UNITED STATES PATENT AND TRADEMARK OFFICE

APPLICATION NO.	FILING DATE	FIRST NAMED INVENTOR	ATTORNEY DOCKET NO.	CONFIRMATION NO.
10/608,494	06/30/2003	Gordon Ennen JR.	306-056	8639

Office Action Summary

DETAILED ACTION

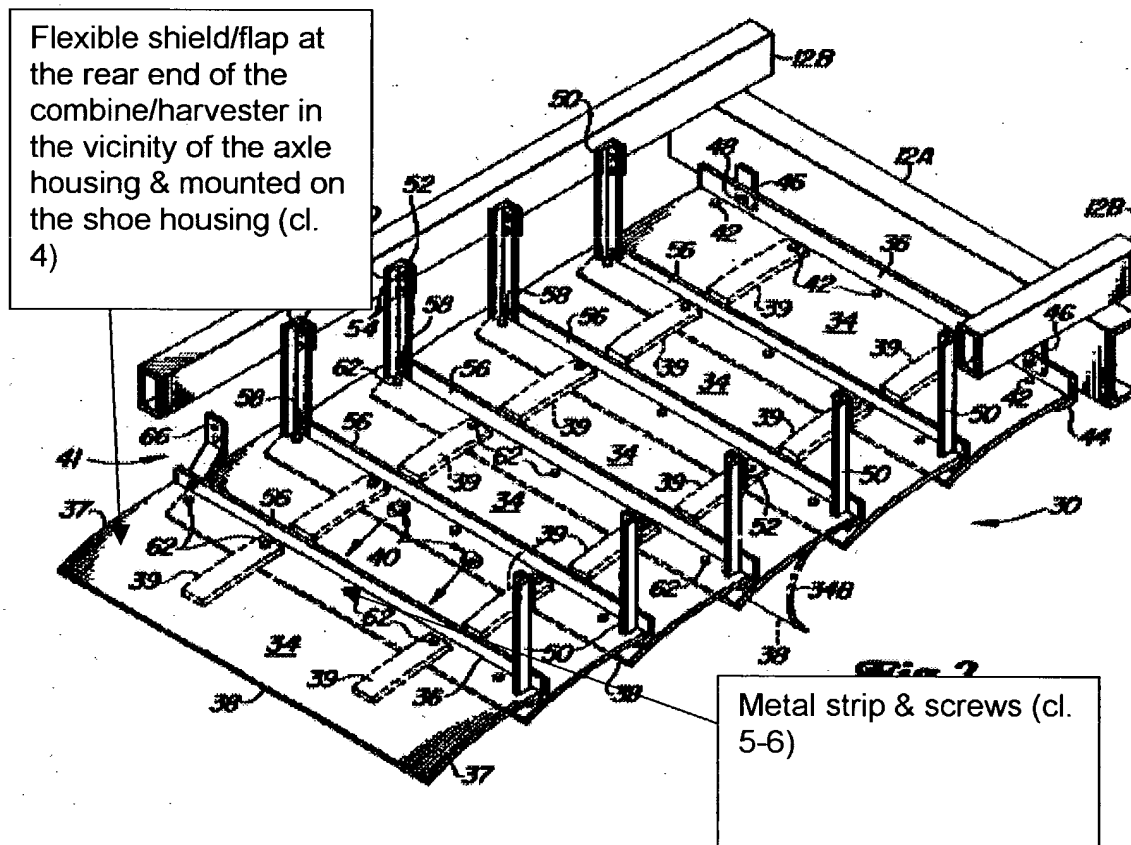
9. Claims 4-6 are rejected under 35 U.S.C. 102(b) as being anticipated by McConnell (5405292).

McConnell discloses and as shown below for greater clarity:

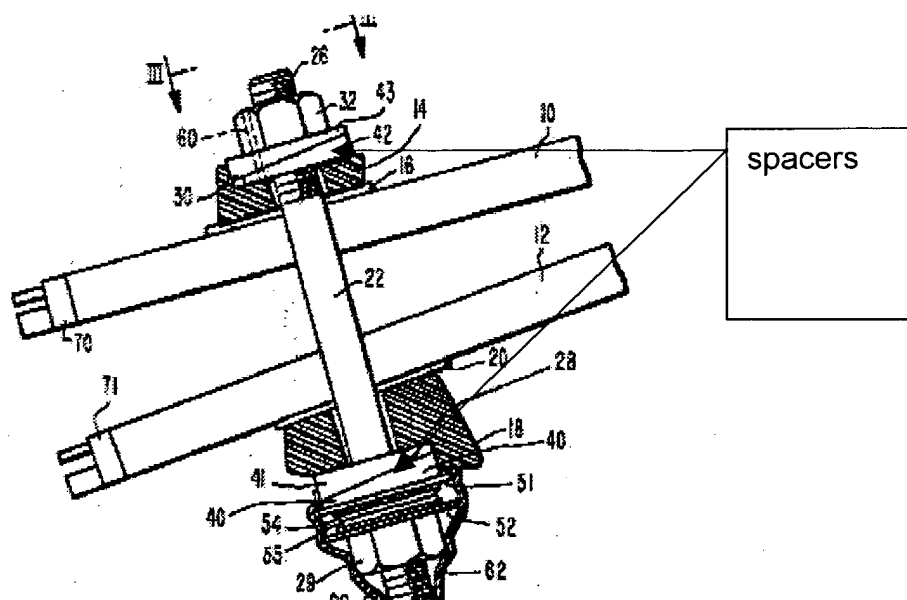
11. Claim(s) 1-3 are rejected under 35 U.S.C. 103(a) as being unpatentable over Applicant's prior art of fig 1, in view of Dailey et al (4415825).

In re claims 1-3, Dailey discloses (as shown below) that it is known in the art to provide spacers, although it has been well known to provide an overwhelming different types of spacers.

It would have been obvious to one having ordinary skill in the art at the time the invention was made to provide the Applicant's prior art of fig 1 with the general teachings in the art of having spacers, in order to minimize slippage between bolts and nuts.
